- 4. Coles Corner No. 3; KPB File 2022-052**  
**Johnson Surveying / Knapp Estate**  
**Location: Kalifornsky Beach Road & Capstan Street**  
**Kasilof Area**

ITEM 4 - COLES CORNER NO 3

KPB File No.	2022-052
Plat Committee Meeting:	May 9, 2022
Applicant / Owner:	Estate of Josephine S. Knapp of Anchorage, AK
Surveyor:	Jerry Johnson / Johnson Surveying
General Location:	Kalifornsky Beach Road, Capstan Street, Kasilof / Kalifornsky APC

STAFF REPORT

## Preliminary Plat

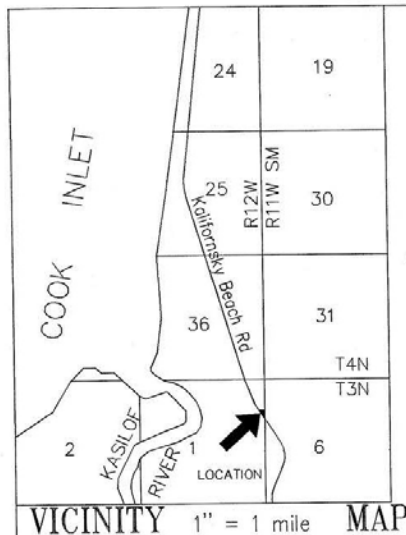
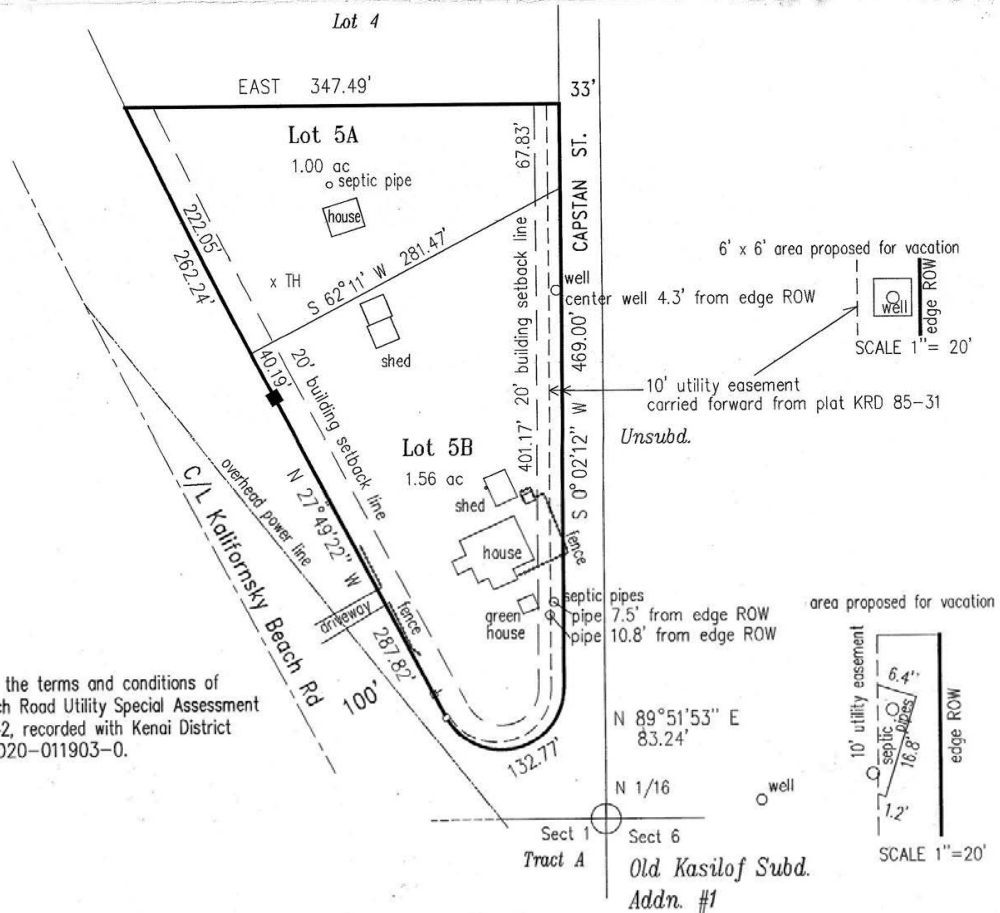
The plat being reviewed states the name is Coles Corner No. 2. The surveyor notified us that it should be Coles Corner No. 3.

*On Lot 5A there is an "x" with "TH" next to the mark. It is unclear what the mark is representing. If it is required or pertinent information it should be included in the legend or plat notes should be added to explain the mark. If it is not required information or pertinent, it should be removed from the final.*

*Structures may be removed from the final but any encroachments should remain with labels.*

**Staff recommendation:** Email from Surveyor stating this will be Coles Corner No 3. Verify the owner's address. KPB records have an Anchorage address instead of Kasilof PO Box.

**Staff recommendation:** *Note the 33 foot side section line easement adjacent to the Capstan Street dedication.*

**Staff recommendation:** *The lot located in Section 6 should have the lot designation of Lot 1-A added. The lot in Section 1 is labeled Tract A, staff found this to be an unsubdivided lot. The lot to the east of Capstan Street should be updated from "Unsubd" to "Government Lot 4".*

**Staff recommendation:** *Per the Kenai Watershed forum information, some wet areas are present along and within Capstan Street. They are classified as drainage way.*

**Staff recommendation:** *The owner/surveyor is working on a utility easement vacation for the encroaching well and septic pipes. A fence is depicted within the setback. The fence is also within the utility easement and appears to possibly be within the right-of-way.*

**Staff recommendation:** Place the following notes on the plat.

- Any person developing the property is responsible for obtaining all required local, state, and federal permits, including a U.S. Army Corps of Engineers wetland determination if applicable.
- Acceptance of this plat by the Kenai Peninsula Borough does not indicate acceptance of any encroachments.
